DEPARTMENT OF TRANSPORTATION

Federal Motor Vehicle Safety Standards; Seat Belt Assembly Anchorages, School Bus Passenger Seating and Crash Protection

ACTION: Final rule; response to petitions for reconsideration.

Figure 5 – Minimum school bus torso belt adjusted height measurement

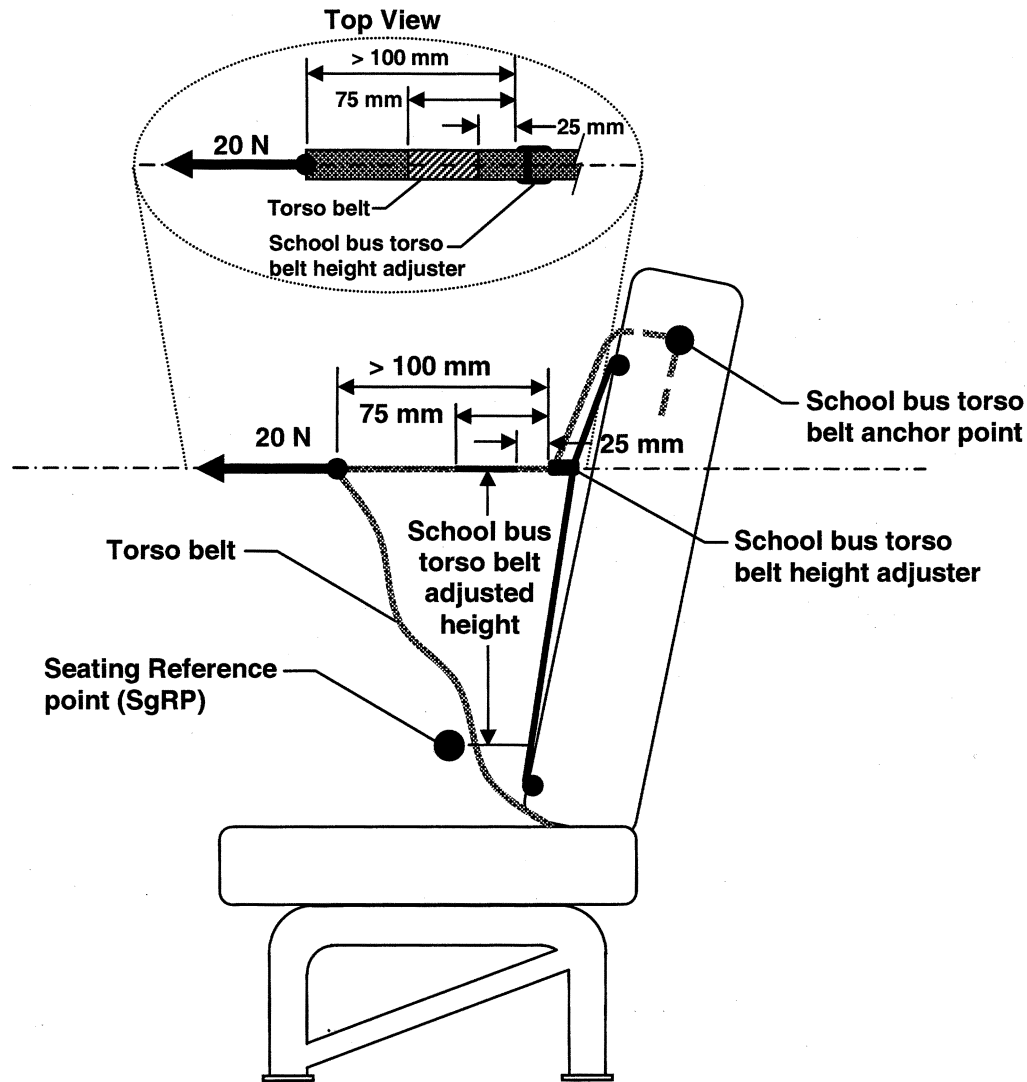
Petition for Reconsideration—In its petition for reconsideration, Blue Bird asked NHTSA to clarify the definition of "school bus torso belt adjusted height," particularly with respect to the phrase "deviates more than 10 degrees from the horizontal plane." Blue Bird stated that it is not possible to pull the webbing in a horizontal plane and maintain the original point of belt contact because the arc of the belt forces load the application device downward since the lower anchor point is fixed.

NHTSA's Response—The request is granted. We are clarifying the definition of "school bus torso belt adjusted height" and adding a new Figure 5 in FMVSS No. 210 to set forth in a clearer, more detailed manner how the torso belt adjusted height measurement will be made. The revised definition removes the confusing phrase "deviates more than 10 degrees from the horizontal plane" and adds a new figure to indicate that the measurement is made to a horizontal segment of the torso belt that is located between 25 mm to 75 mm (1 in to 3 in) forward of the adjustment device while applying a horizontal 20 N

(4.5 lb) force to the belt in the forward direction. The 20 N (4.5 lb) horizontal force is applied in the forward direction through the webbing at a location greater than 100 mm (3.94 in) forward of the adjustment device (as shown in the new Figure 5) after the retractor has been locked. Figure 5 also illustrates that slack should remain in the portion of the belt between its bottom anchorage and the point of force application. This slack allows the upper portion of the torso belt, between the point of force application and the adjuster, to be pulled in a horizontal plane. We believe these amendments address the petitioner's concerns.

School bus torso belt adjusted height means the vertical height above the seating reference point (SgRP) of the horizontal plane containing a segment of the torso belt centerline located 25 mm to 75 mm forward of the torso belt height adjuster device, when the torso

belt retractor is locked and the torso belt is pulled away from the seat back by applying a 20 N horizontal force in the forward direction through the webbing at a location 100 mm or more forward of the adjustment device as shown in Figure 5.
